SAXTON NUCLEAR EXPERIMENTAL CORPORATION

DOCKET NO. 50-146
LICENSE DPB

Amendment No. 1 to Change Request No. 25

1. Applicant hereby submits Amendment No. 1 to Change Request No. 25 supplying additional information requested in Division of Reactor Licensing letter of April 12, 1967.

SAXTON SAFETY VALVE
WITH ANTI-SIMMER DEVICE

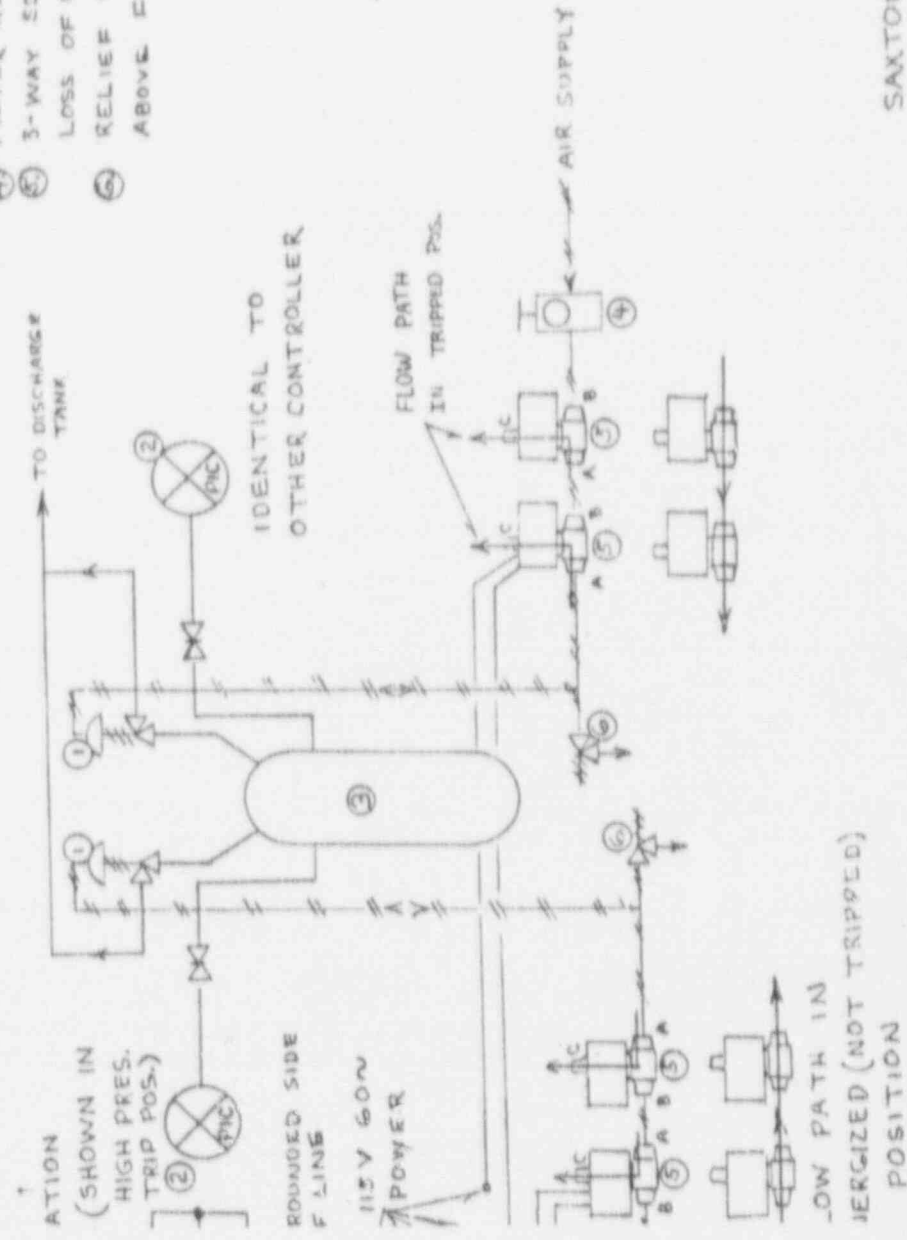
II. A. 3 Please supply an electrical schematic diagram of the anti-simmer circuits.

II. A. 4 Can a single solenoid valve vent the full capacity of the pressure regulator?

The electrical schematic diagram of the anti-simmer device circuit is shown in Figure II. A - 3 which supersedes Figure III - 1 of the Saxton 35 MWt Safety Report.

The solenoids are not intended to vent the pressure regulator, however the relief valve can vent the full capacity of the pressure regulator thus insuring that the assist does not exceed 4% of the safety valve set pressure. Either solenoid valve can vent the anti-simmer operator and thus unload the assist completely. See Figure No. II-A-3.

- ① AIR LOADED, SPRING OPERATED SAFETY VALVE
- ② PRESSURE INDICATING CONTROLLER
- ③ PRESSURIZER
- ④ FILTER REGULATOR WITH GAUGE
- ⑤ 3-WAY SOLENOID VALVE. UPON LOSS OF POWER, VALVE VENTS ATOC
- ⑥ RELIEF VALVE. SET APPROX 275 ABOVE FILTER REGULATOR (4).

FIG. III-2 - MODIFICATION OF SAXTON REACTOR TRIP CIRCUITS

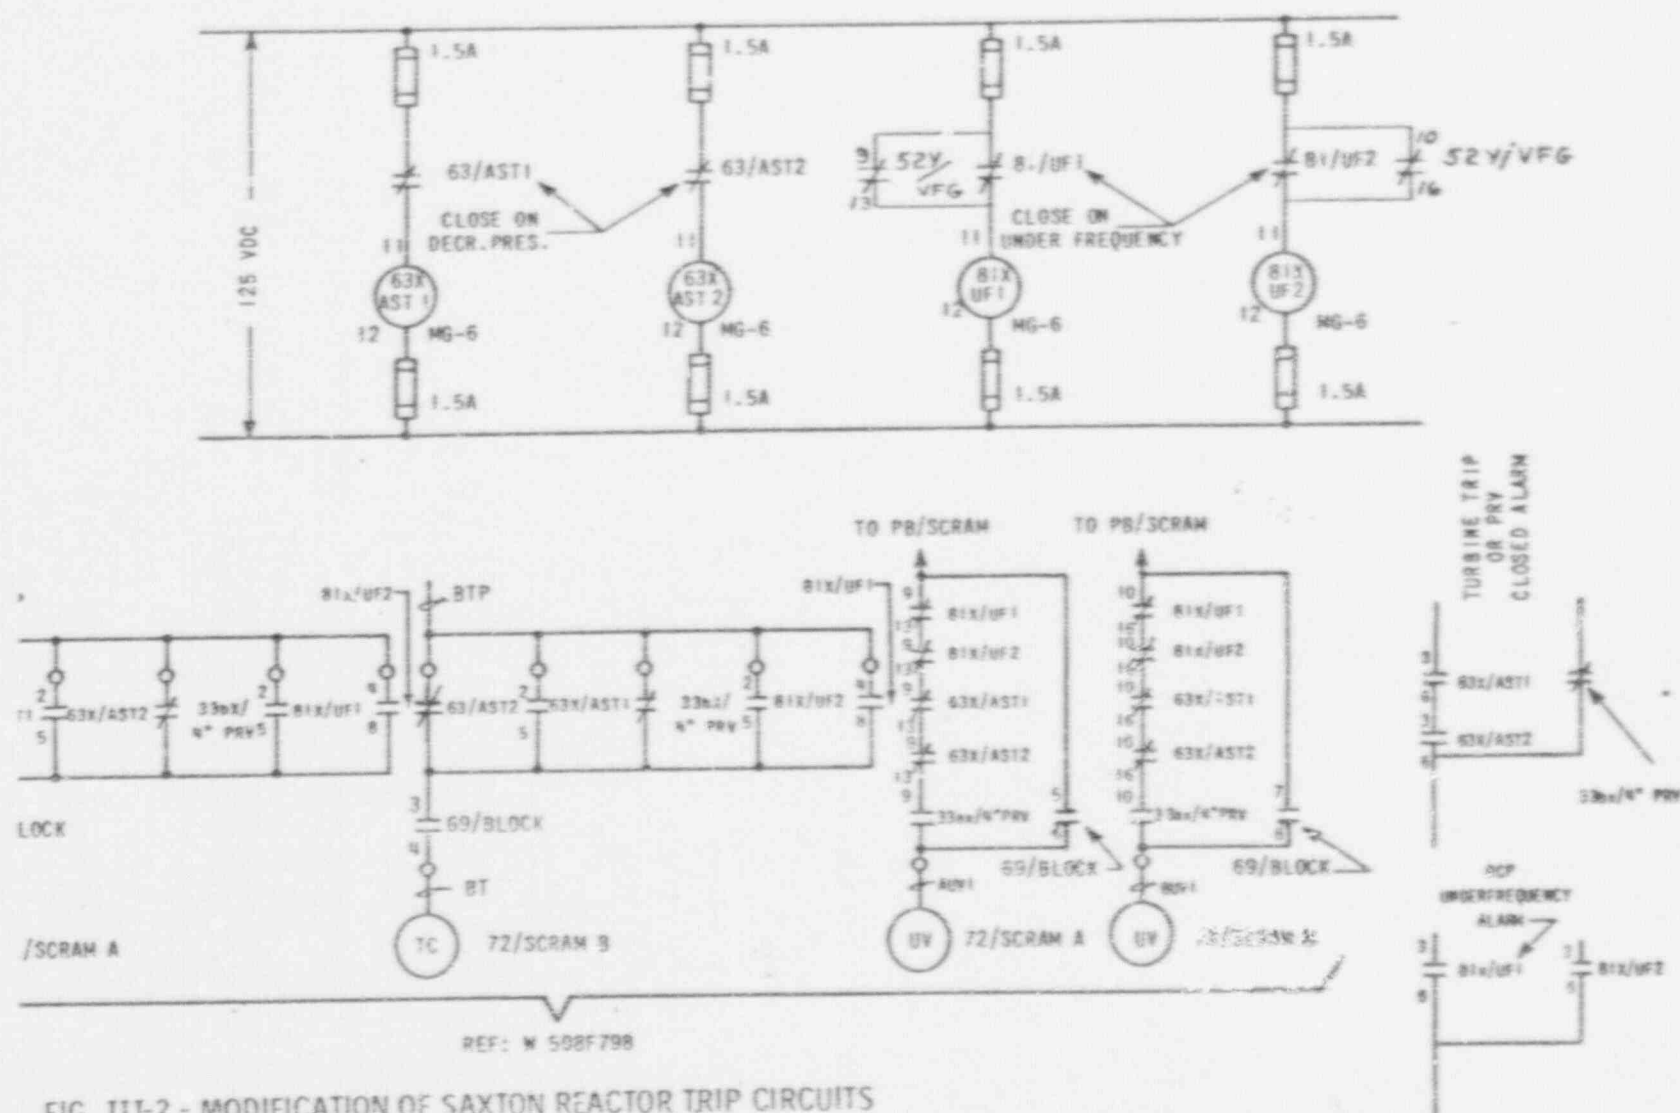
- II. B. 1 Please supply a schematic diagram similar to Figure III.2 showing the existing reactor trip circuits as well as the added circuits.

See Revised Fig. III-2

FIGURE III-A

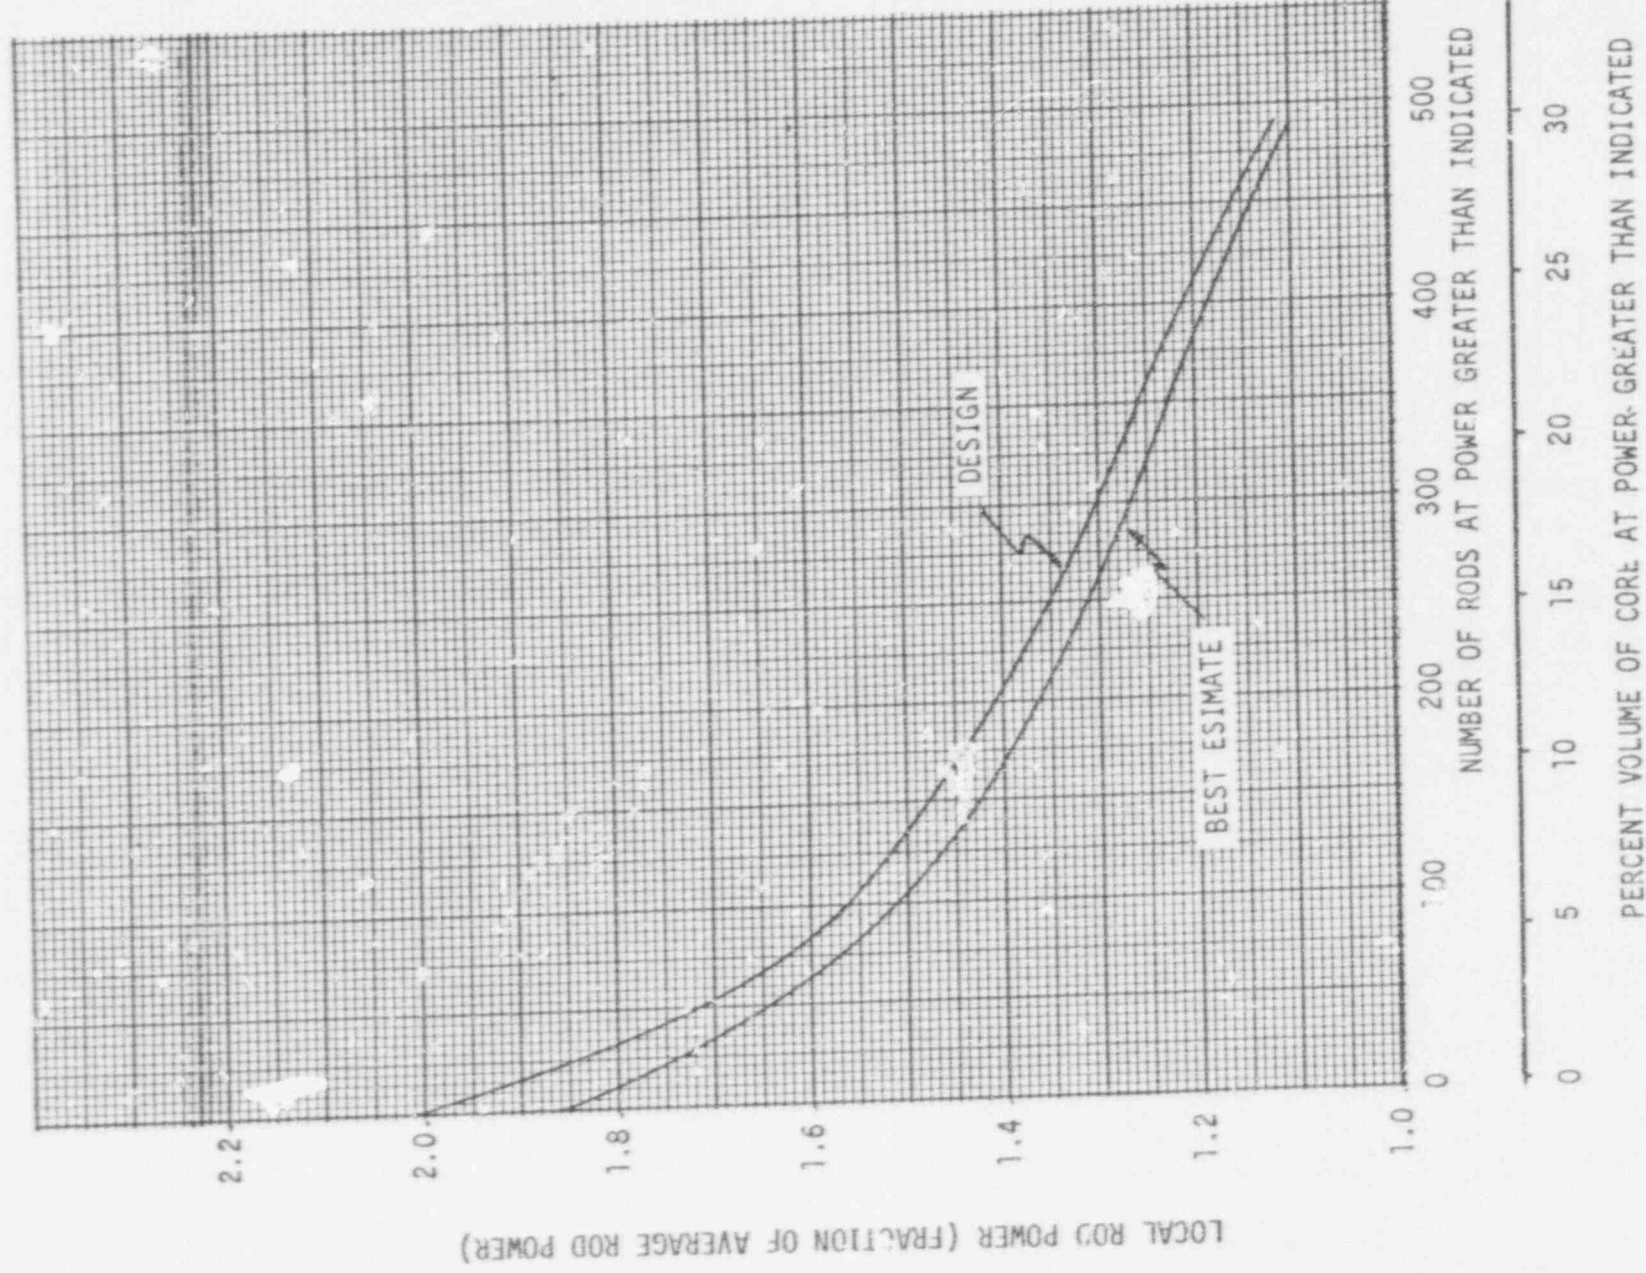
- III. A. Prepare a distribution curve showing the fraction of the core (and number of rods) operating at the various power levels for design and overpower conditions.

The design and best estimate radial power distributions are plotted in Figure III-A. The design curve is used for both the design power and overpower cases, unless otherwise specified.

HYDROGEN PICKUP FOR ZIRCALOY IN SAXTON

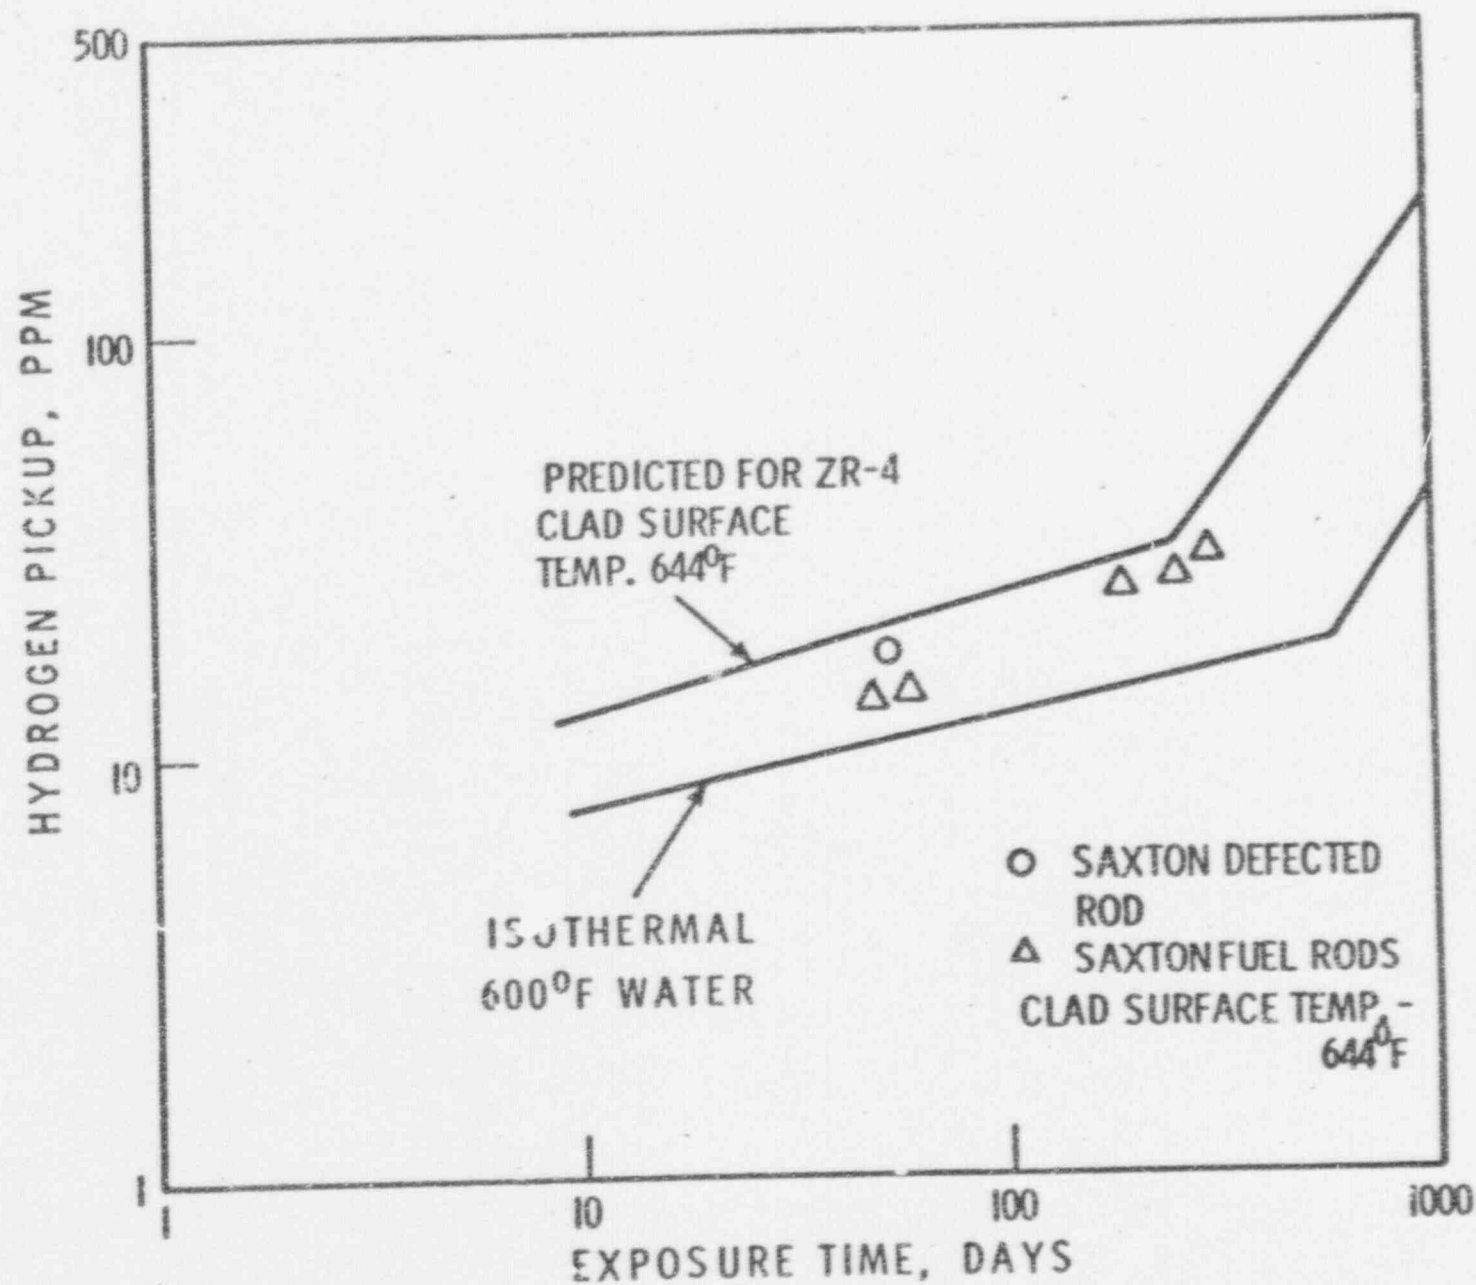
- IV. F. Is there experimental data available on hydrogen absorption by cladding that goes beyond the burnups and power level of Reference 3 page V-3? What is the effect of hydrogen absorption by cladding on its fatigue properties and what is the combined effect of hydrogen absorption and radiation embrittlement?

Hydrogen content of the irradiated cladding was determined by hot extraction techniques and metallography of the irradiated fuel rod cladding. The hydrogen pickup of the cladding while operating in Saxton is illustrated in the attached Figure IV-F. The results

are compared with out-of-pile tests in 600°F water and the computed hydrogen pickup for Zircaloy-4, when operating at 644°F surface temperature. The hydrogen absorption by the cladding does not differ from out-of-pile results. WAPD observed that 20 to 35% of the hydrogen produced by the corrosion reaction was absorbed by the clad.

The hydrogen pickup of the defected rod is also in agreement with the results for other Zircaloy clad rods in Saxton and the predicted hydrogen pickup for Zircaloy-4. The value (18 ppm) is equivalent to absorption of 21% of the amount of hydrogen produced by the corrosion reaction.
